ADDENDUM No. 2

ADD-002

Project Title: **WCDSB St. Greg Addition**
 Project No.: **25-106 – WCDSB Tender RFT 2026-01**
 Owner: Waterloo Catholic District School Board
 Prime Consultant: J.P. Thomson Architects Ltd.

FIRST FLOOR DOOR SCHEDULE

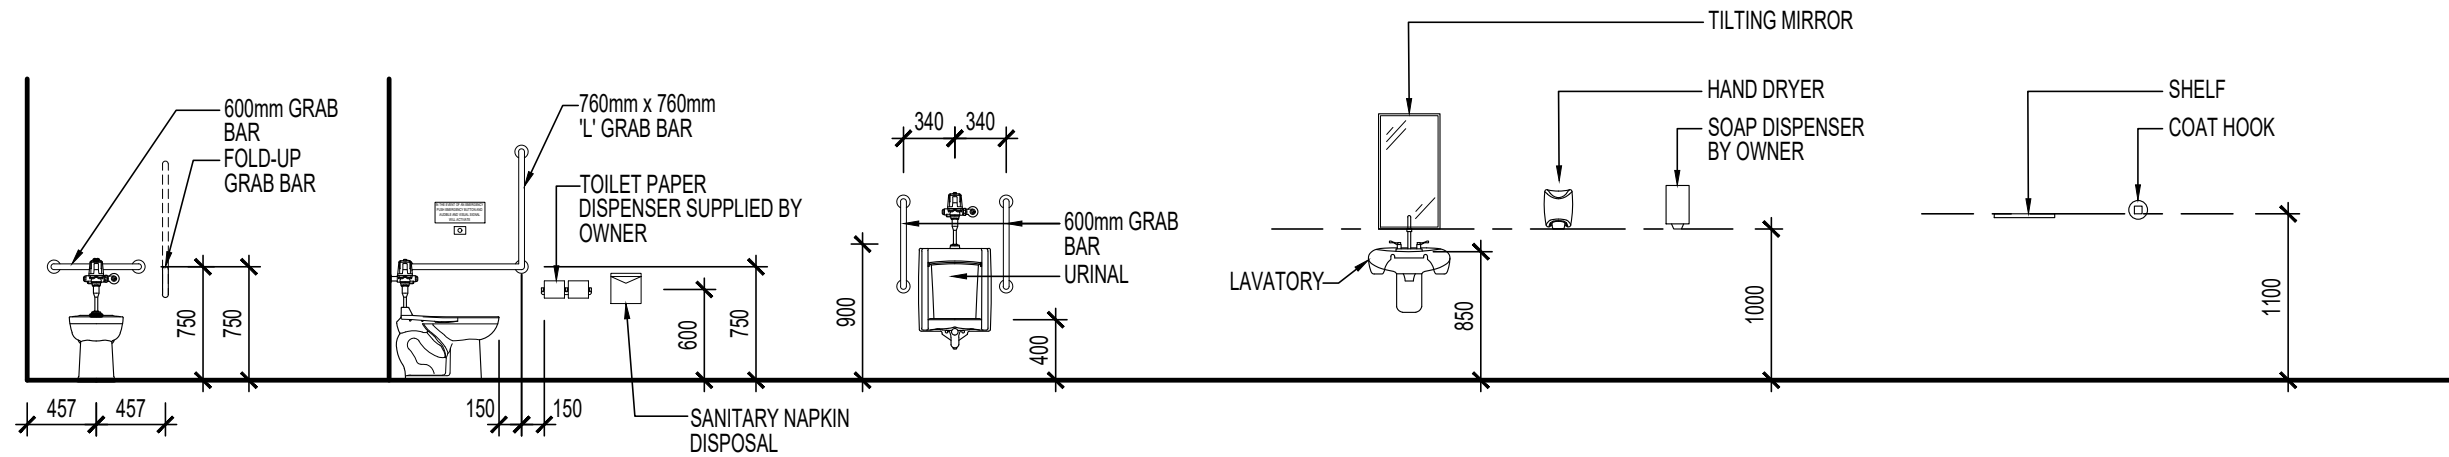
Item No. 2.6	<p>Refer to attached Finish Hardware Schedule</p> <ul style="list-style-type: none"> .1 Remove Door C101 .2 Add Door 201.2
Item No. 2.7	<p>Refer to attached Sketch A-104.2</p> <ul style="list-style-type: none"> .1 Provide New 45 min. Rated Door Frame at Door 201.2. .2 Tooth-in Masonry as required for installation of new frame. .3 Revise Door 201.1 to be a single door in lieu of double door, matching drawing A-201. .4 Revise Door 101.1 to carry Frame Elevation #1 In lieu of #2.

6 SECTION
A-605 SCALE: 1:20

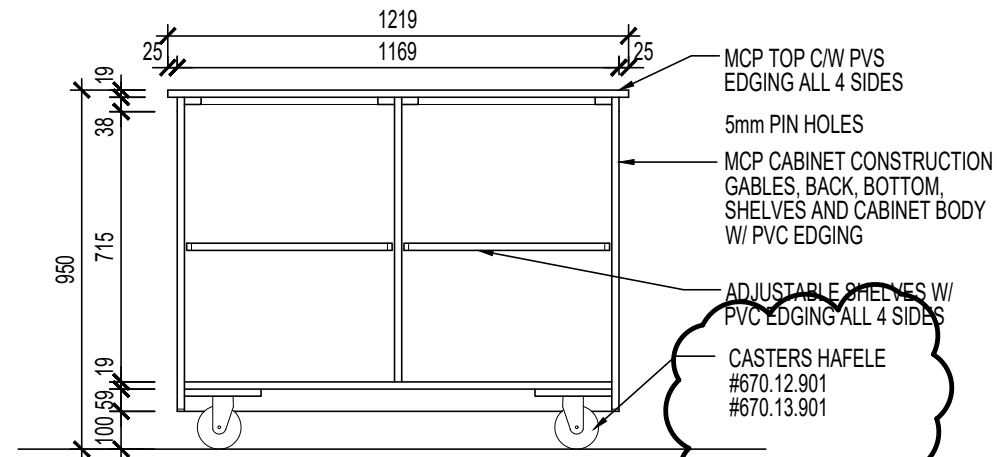
Item No. 2.9	<p>Refer to attached Sketch A-601.1</p> <ul style="list-style-type: none"> .1 Revise Section 6 and 7 to include the name of specified casters.

14 SECTION
A-601 SCALE: 1:20

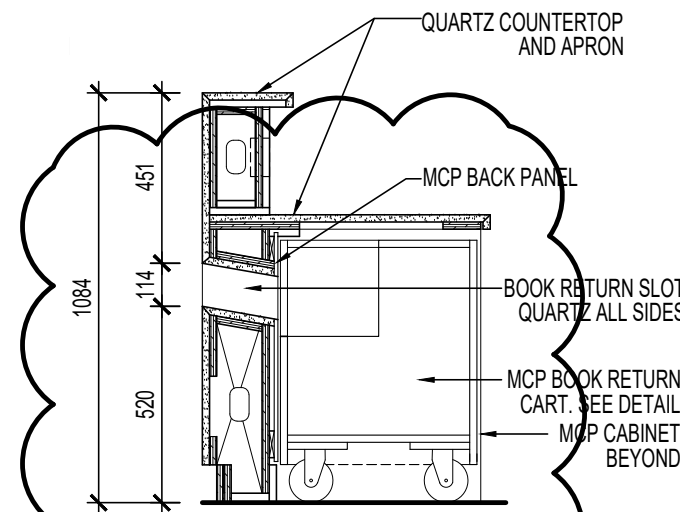
.2 Revise Section 14 and 16 to include and name the specified casters.
Item No. 2.10	<p>Questions and Answers</p> <p>Question 1: What is the warranty on the project?</p> <p>Answer 1: Refer to Specifications, Supplementary Conditions, SC55, GC12.3</p> <p>Question 2: Are alternate equal products allowed on the project or is all equipment as per drawing M-000?</p> <p>Answer 2: See above</p> <p>Question 3: Spec Section 06 40 00 does not specify a colour for MCP. Melamine sheets vary significantly in cost depending on the selected colour. Please advise. Could you please confirm if Hard Rock Maple melamine is acceptable for pricing purposes?</p> <p>Answer 3: Use Hard Rock Maple as this will match existing conditions.</p> <p>Question 4: Can this tender be kindly extended by a week?</p> <p>Answer 4: As per owner's preference, tender is to close on May 21st.</p> <p>Question 5: Please clarify the correct tender closing date, as Section 00 41 00 of the specifications indicates May 19th, while the bids and tender system lists May 21st. Which date should we follow?</p> <p>Answer 5: Refer to Addendum 1. Owner is to update bid portal to reflect changes.</p> <p>Question 6: What is the extent of new flooring required in Corridor C101, considering that part of it is within the new addition and the remainder is in the existing building? Should the new flooring continue through the entire corridor, or stop at the transition point where the addition meets the existing building?</p> <p>Answer 6: Refer to Addendum 1. Existing terrazzo patch and floor transition has been identified. New finished floor is to match top of existing terrazzo floor.</p> <p>Question 7: Specification 06 40 00, 1.9.11 notes for all 4 edges of shelving to be edged, please confirm if the front edge can be 3mm and the sides and back can be thin tape?</p> <p>Answer 7: Provide 3mm edging to all four sides.</p> <p>Question 8: Section 1/A-600 notes for the 35mm doors to be made out of 2 layers of 13mm melamine w/ a 9mm spacer, please confirm if it is acceptable to have a 35mm solid core door finished in laminate to match the melamine?</p> <p>Answer 8: Provide 35mm doors as shown in architectural drawings</p> <p>Question 9: Is there any required product for the casters - refer to section 7/A-600?</p> <p>Answer 9: Refer to above</p>

16 SECTION
A-601 SCALE: 1:20

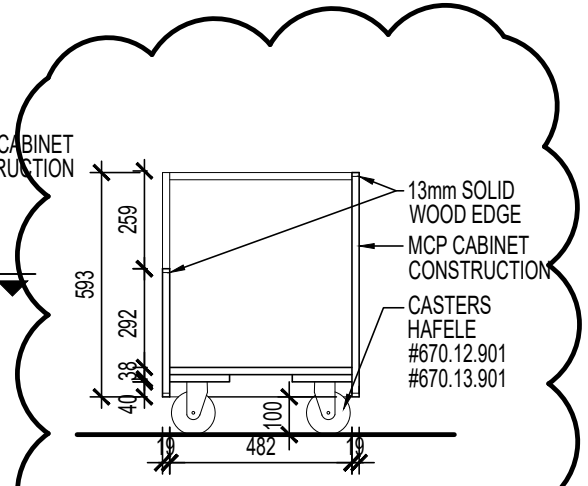
Question 10: 16/A-600 Notes MCP construction with 13mm Solid wood edge, This is not practical, as the edge will need to get at least a lacquer finish, meaning you have to tape the rest of the millwork. Please confirm a 1mm or 3mm pvc edge is acceptable?

Answer 10: Provide MCP construction with 13mm Solid Wood Edge as shown in architectural drawings
